## SERVICE BULLETIN #01-51719

### PSS Shaft Seal: Shaft Targeting

Applies To: PSS Type A, PRO, Type B Shaft Seals

May 17, 2019

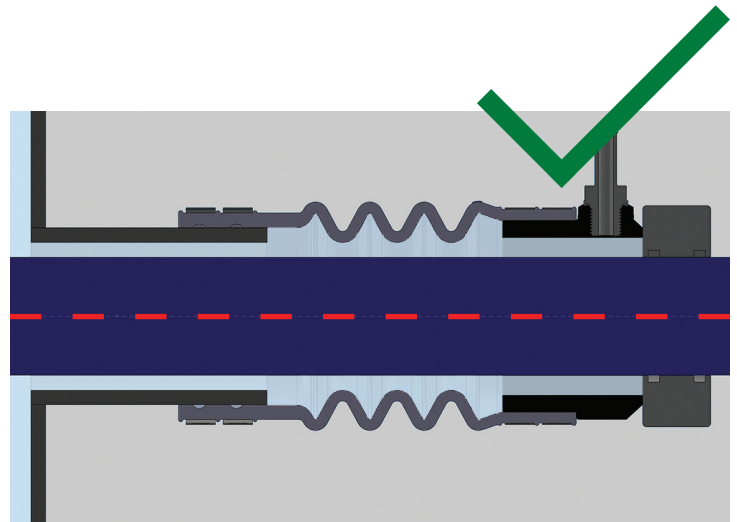
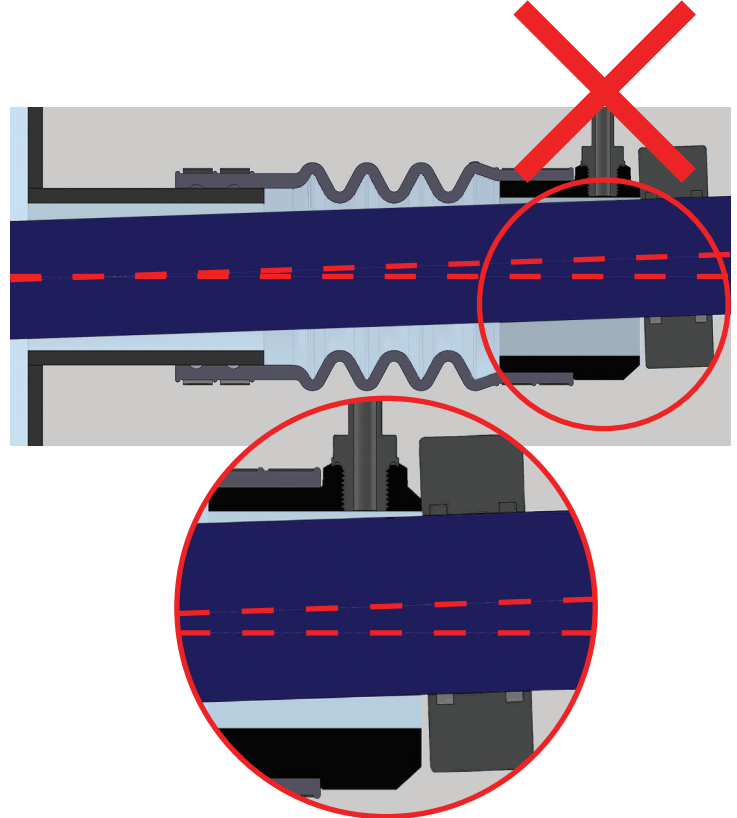
The carbon flange is over-bored to compensate for most misalignment issues, however, there are several boat models that have ‘shaft / stern tube targeting’ issues beyond what the carbon flange ‘standard bore’ can make up for. Shaft targeting (often confused with alignment) is a factor of shaft / stern tube orientation where the shaft is not centered in the stern tube where it enters / exits the boat and or the stern tube not running parallel to the shaft. The result (as depicted to the right) is a shaft that passes through the assembly at an angle and the outcome can be a leaking seal (notably at high rpm) due to the shaft contact inside the carbon flange disrupting the mechanical seal.

**Step 1:** Adjust the bellow angle on the stern tube in a way that allows the shaft to pass through the center of the carbon component. On a boat with only slight off center shaft or small parallelism issue this fix is usually sufficient.
